SINCLAIR COMMUNITY COLLEGE  
Dayton, Ohio

Addendum No. 1

TO THE DRAWINGS AND SPECIFICATIONS FOR:  
PROJECT NO. FAC 15-13X.9  
RESTROOM REFRESH BUILDING 14

Prepared by:  
The Oregon Group Architects  
300 S. Patterson Blvd.  
Dayton, Ohio 45402  
937-228-1511

ADI.I

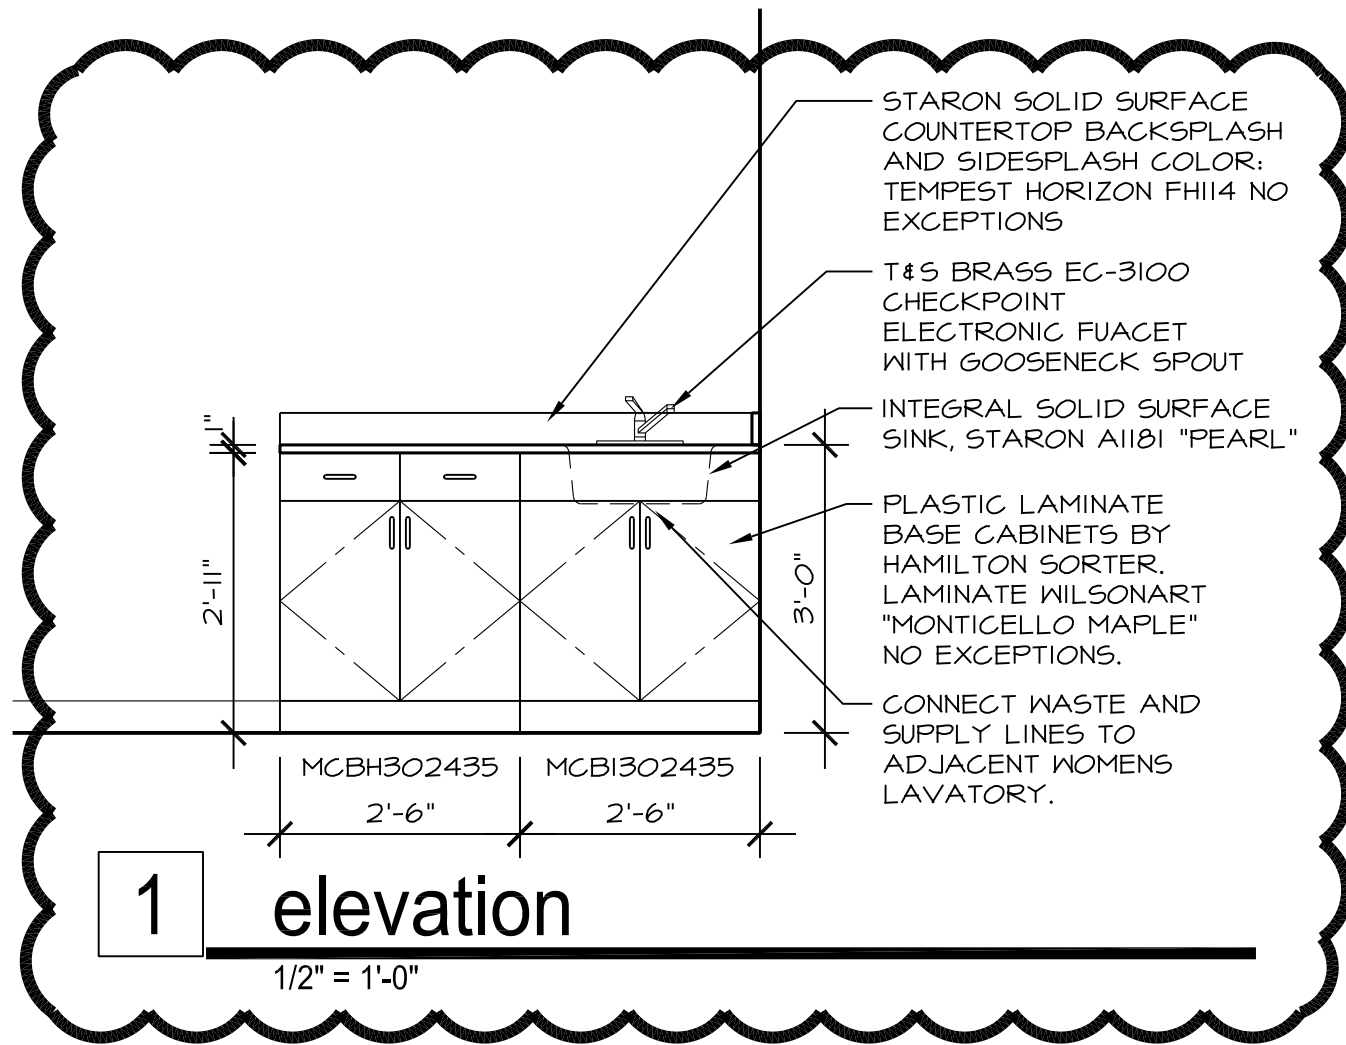
- Item No. 6:** Drawings A1.1 thru A1.4, Coded Note #13:
- A. At each new 18" vertical grab bar remove tile and substrate as required to install wood blocking. Repair wall as required and re-install salvaged tile.
- Item No. 7:** Drawing A0.1 – Lighting Fixture Schedule
- A. Change Light Fixture "B1" to Lithonia Lighting 2RTL, 3300 Lumens, 120-277V, EZ1 Driver, LP835 3500K Color Temperature. No substitutions.
- Item No. 8:** Drawing A1.1 – Additional Casework and Sink
- A. Reference partial plan and interior elevation of new casework, countertop and sink to be installed in basement room #012 adjacent to the Women's Restroom. Drawing sheet AD1.1 is attached to this addendum.
